Appendix G: RFLMA Contact Records

RFLMA contact records issued during 2011 are included in this appendix.

ROCKY FLATS SITE REGULATORY CONTACT RECORD

Purpose: Replace Mound Site Plume Treatment System (MSPTS) media and maintain/repair discharge gallery.

Figure 1. Sampling Location Map

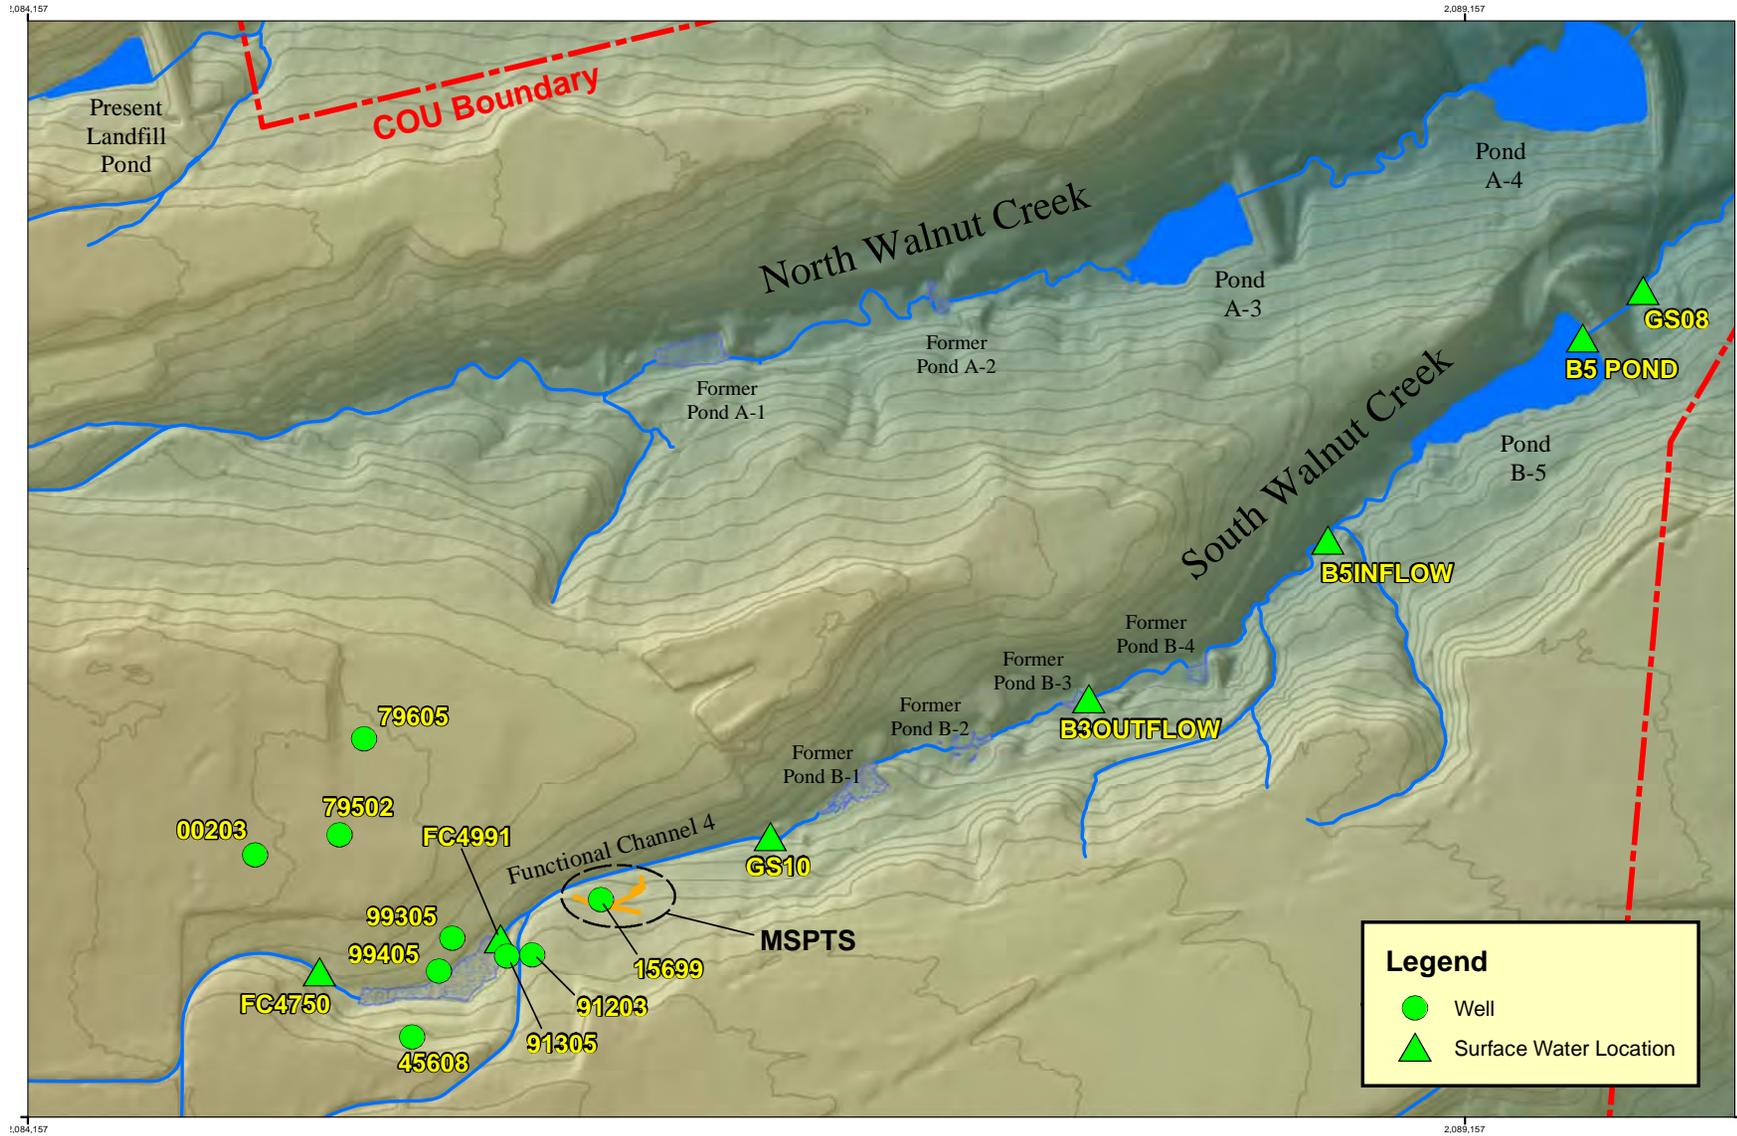
Discussion: This Contact Record documents DOE's consultation with CDPHE and EPA on September 12, 2011 regarding the evaluation of the reportable condition at surface water Point of Evaluation GS10. All sampling locations discussed in this Contact Record 2011-05 are shown on Figure 1 at the end of this document.

Results for samples from GS10 and relevant upstream and downstream surface water locations collected in 2011 are provided below in Tables 1 through 3, and a map illustrating these locations is attached as Figure 1. A sample for the analysis of uranium was also collected on December 21, 2010, from the Mound Site Plume Treatment System (MSPTS) effluent, and uranium was not detected at a detection limit of 1 µg/L. The MSPTS effluent discharge gallery is upstream of GS10.

Based on the LANL results for GS10, the RFLMA Parties agreed the following additional sampling data will help inform the ongoing evaluation.

- The following samples will be collected and sent to LANL for isotopic analysis to determine the percentages of natural and anthropogenic uranium.
 - Flow-paced surface water sample from GS10 to help confirm the previous sample results.

- Grab sample at surface water locations FC4750 and FC4991.
- Flow-paced surface water sample from B5INFLOW. This location does not have a previous LANL sample.
- Grab sample at a surface water location B3OUTFLOW in South Walnut Creek, which is between GS10 and B5INFLOW. One post-closure LANL sample was taken at B3OUTFLOW. The result was a 74.3 percent natural uranium signature.
- Wells 45608, 91203, 91305, and 15699, which are upgradient of GS10, will be sampled for uranium, and a sample from one of these wells will be selected for LANL analysis based on the uranium concentration. Of these, only well 91305 includes uranium as a routine RFLMA analyte.

Figure 1. Project Location and Extent of Excavation

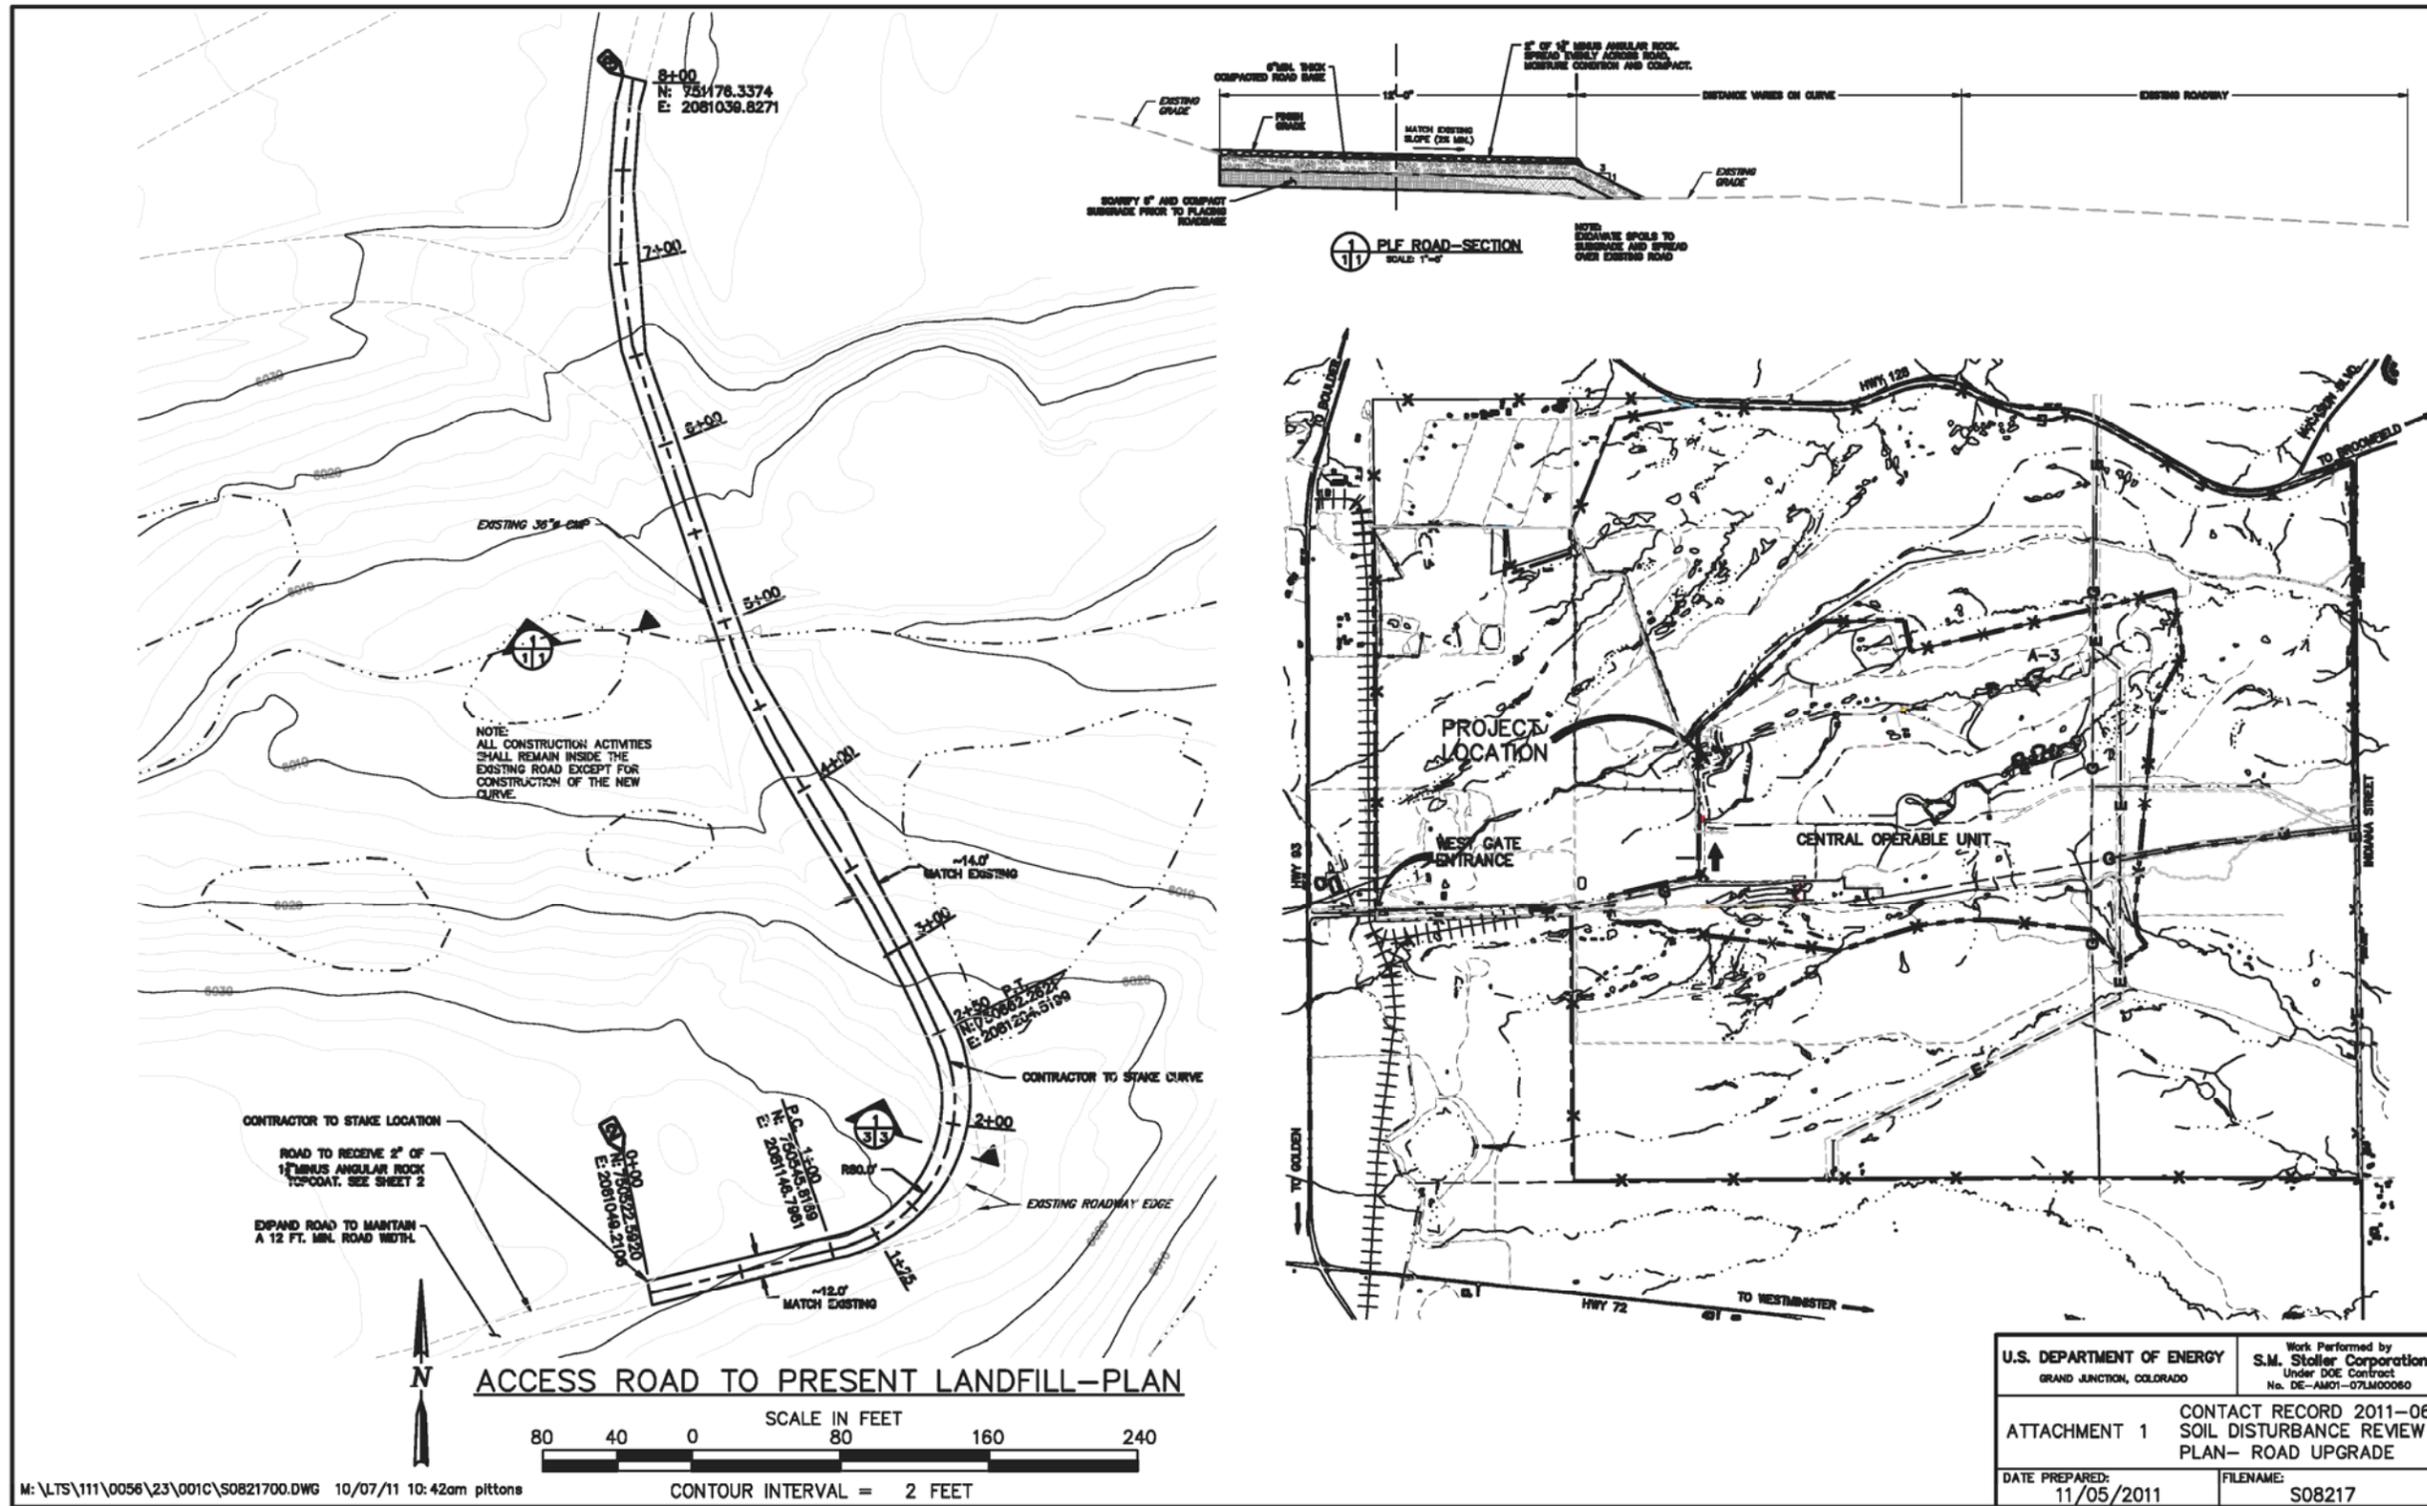
The purpose of the project is to maintain and improve the section of gravel road shown in Figure 1. The improvement regrades the area and takes out a sharp curve that is on the edge of a sloping embankment to result in wider radius curve that is farther away from the sloping embankment. The planned location, lateral and vertical extent, and grade upon completion of the work are shown in Figure 1. The excavation for regrading this portion of the road will be approximately 6 feet deep at the deepest portion.

This characterization information is sufficient for DOE to implement appropriate worker health and safety controls for the soil disturbance. Disturbed soils will be regraded in the work area as shown in Figure 1.

Resolution: Carl Spreng, CDPHE, approved the soil disturbance and excavation work described in the Soil Disturbance Review Plan.

Figure 1. Dam A-3 Breach Construction

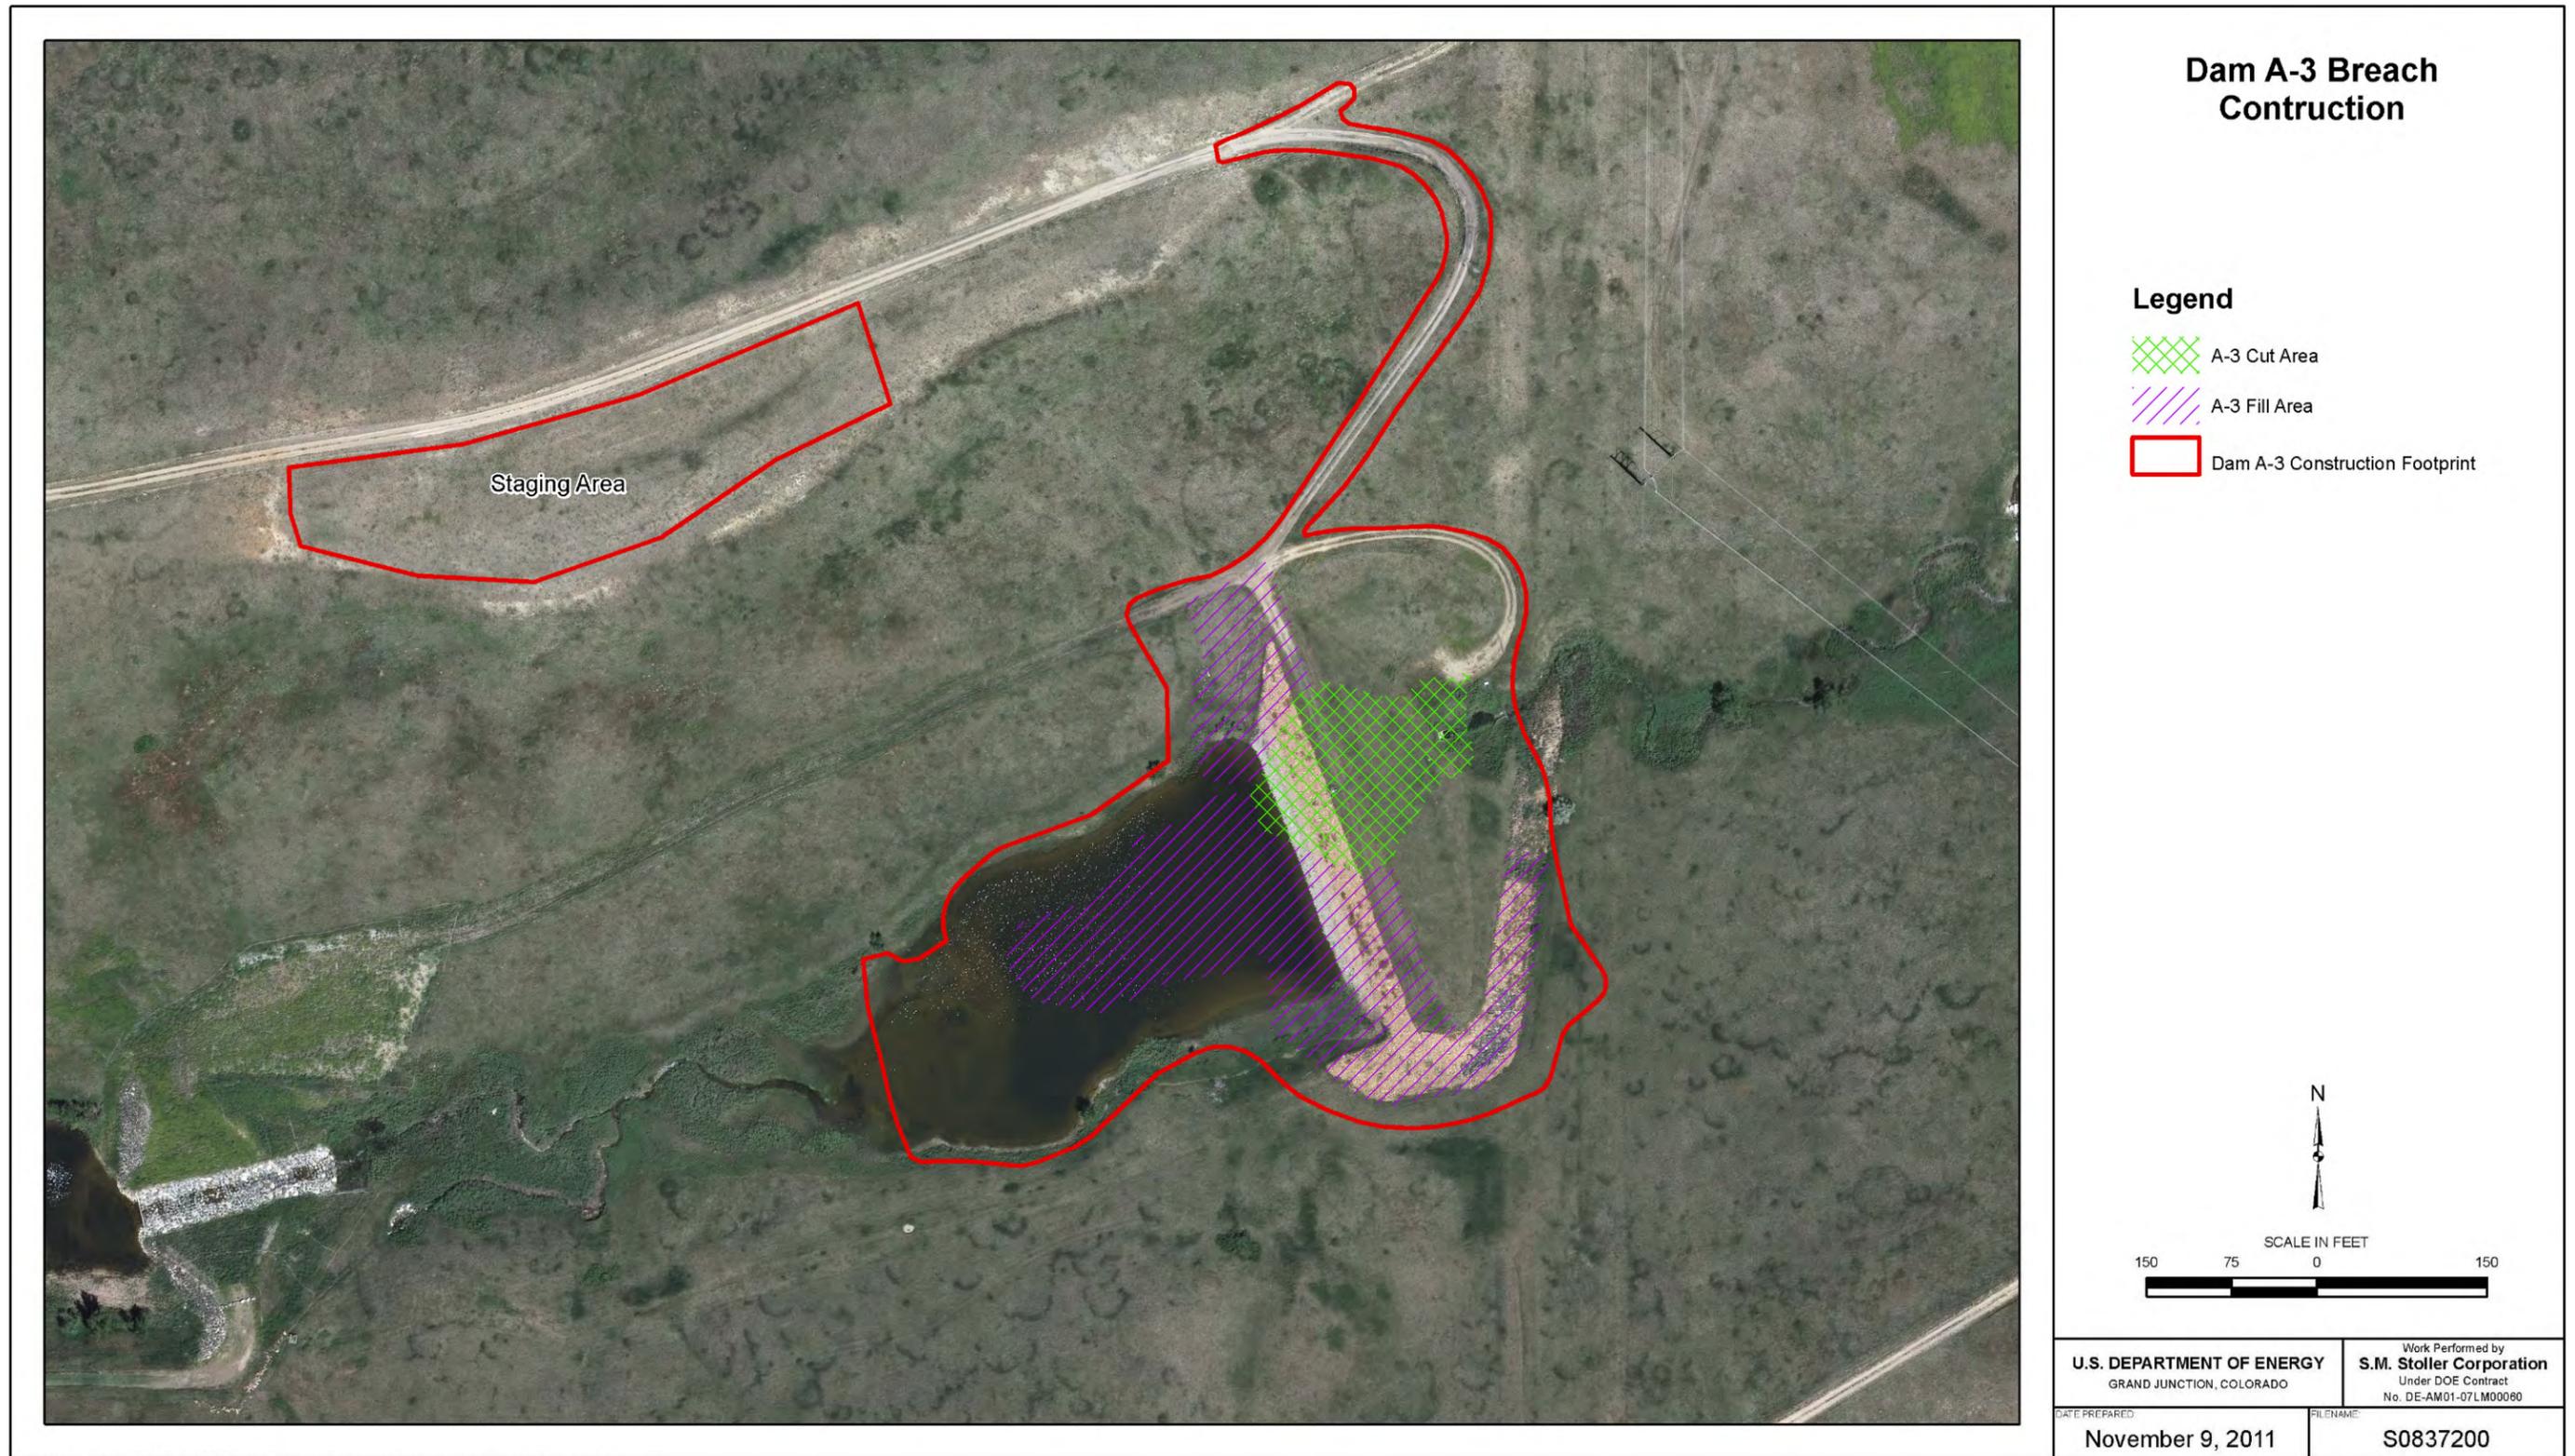
Figures 1 through 5 show the location and the lateral and vertical extent of the excavation. The material excavated for the cut areas will be placed in the fill areas as shown in Figures 1 and 2.

This characterization information is sufficient for DOE to implement appropriate worker health and safety controls for the soil disturbance. Excavated soils will be regraded in the work area as shown in Figures 1 and 2.

Resolution: Carl Spreng, CDPHE, approved the soil disturbance and excavation work described in the Soil Disturbance Review Plan.
